Interactive comment on “Accurate stream extraction from large, radar-based elevation models” by M. Metz et al.

Reply to comment n.1

Fig. 1.

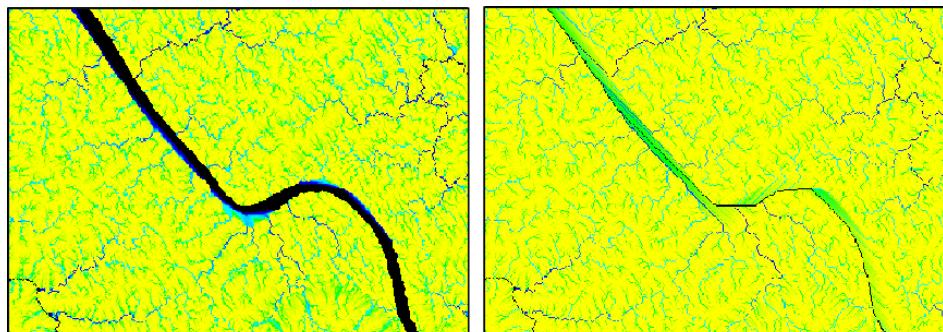
MFD for channel cells, we observed more realistic results using MFD instead of some SFD method for channel cells where the channel is several cells wide (see Figure 1 of this comment)
